Docket Number:	14-AAER-02
Project Title:	Computer, Computer Monitors, and Electronic Displays
TN #:	211226
Document Title:	California Investor Owned Utilities Comments: Computers - Response to Standards Proposal
Description:	CA IOUs Title 2 Computers Workshop 2016-04-26
Filer:	System
Organization:	California Investor Owned Utilities
Submitter Role:	Public
Submission Date:	4/25/2016 8:48:38 AM
Docketed Date:	4/25/2016

Computers

Response to Standards Proposal

Presented to the California Energy Commission

Expandability Adder

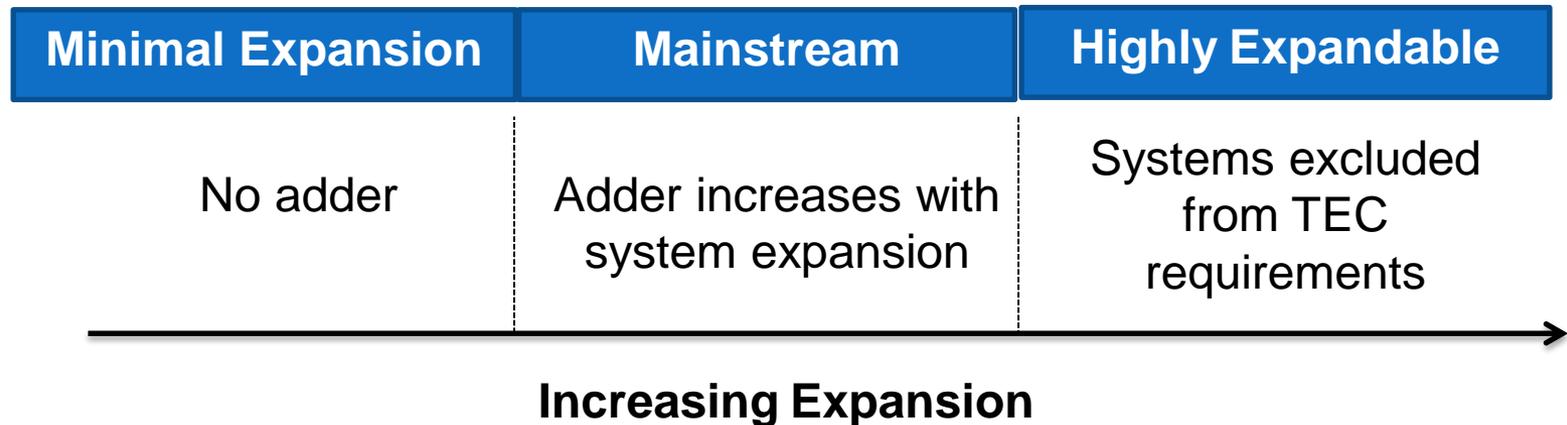
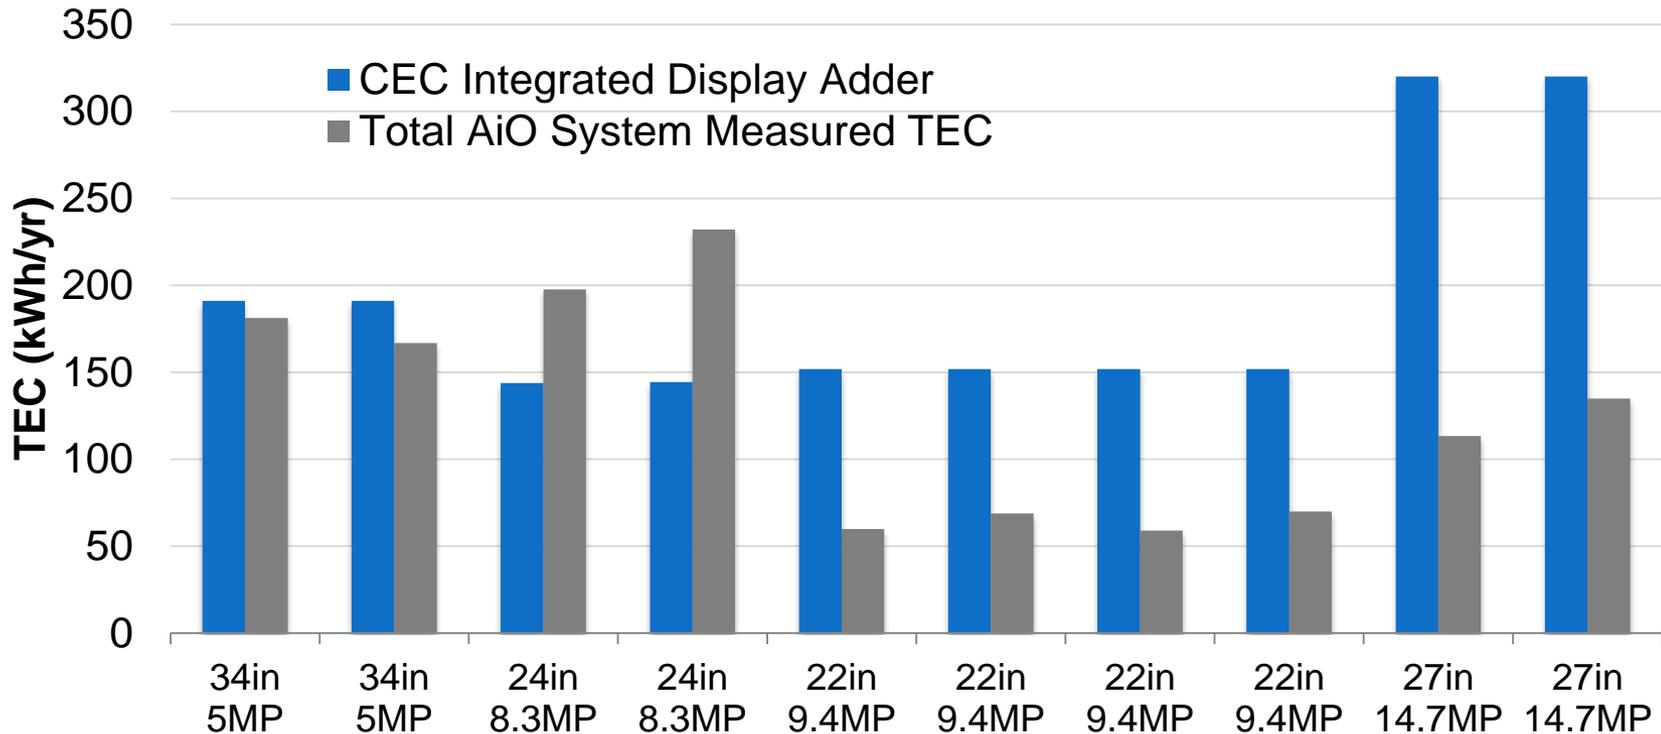
IOUs support CEC's expandability framework to address needs of highly expandable desktop systems

Two key areas for refinement and clarification:

- Expandability score calculations
- Criteria for exemption from TEC requirements

TEC Impacts of 3.5" HDDs

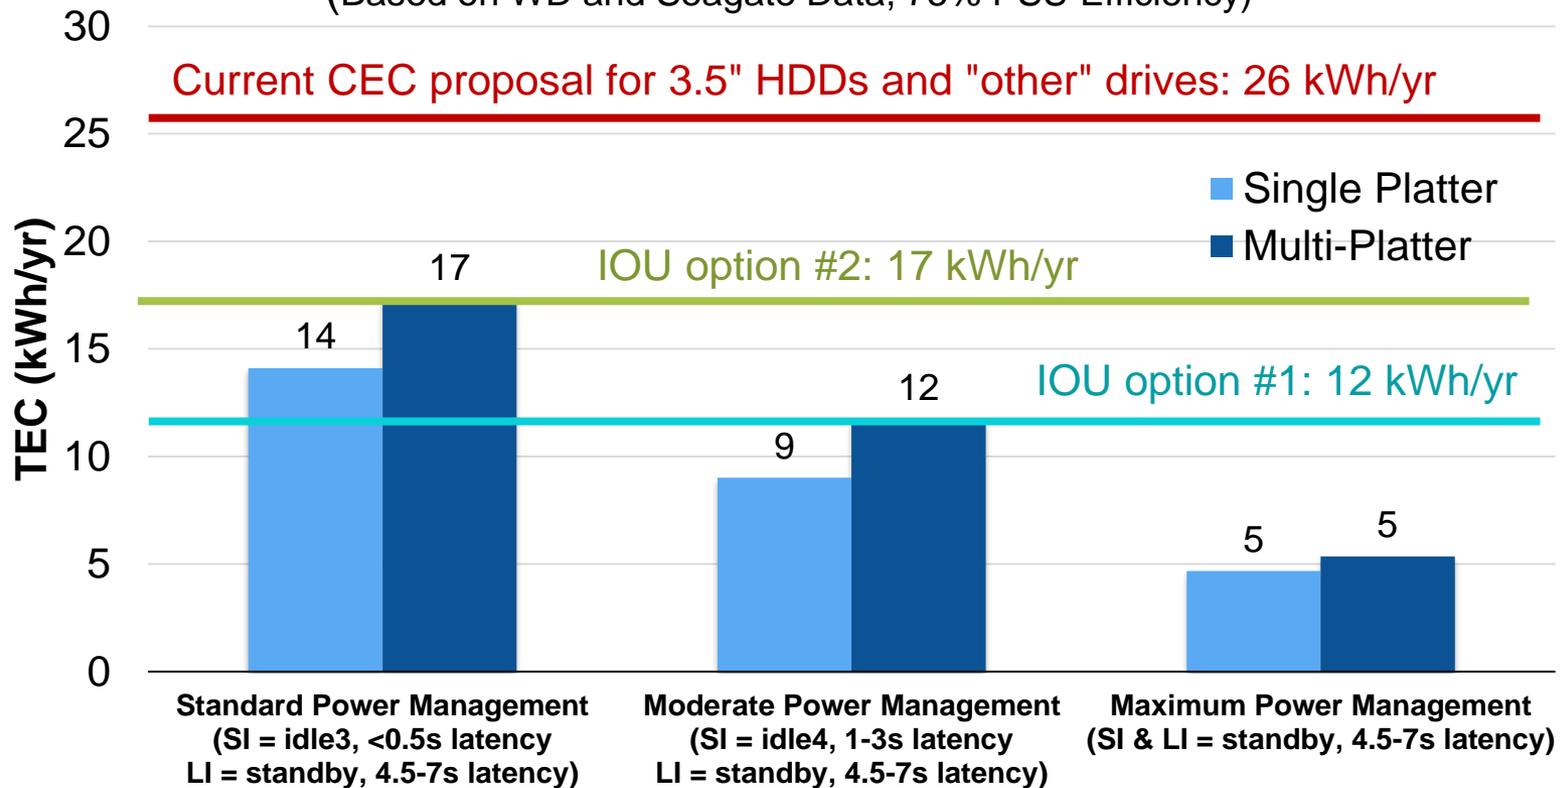
CEC should tighten secondary storage adders for 3.5" HDDs (12-17 kWh/yr possible with modest PM)

Lacking data, adder for "other" drives should match solid-state memory (0.5 kWh/yr)
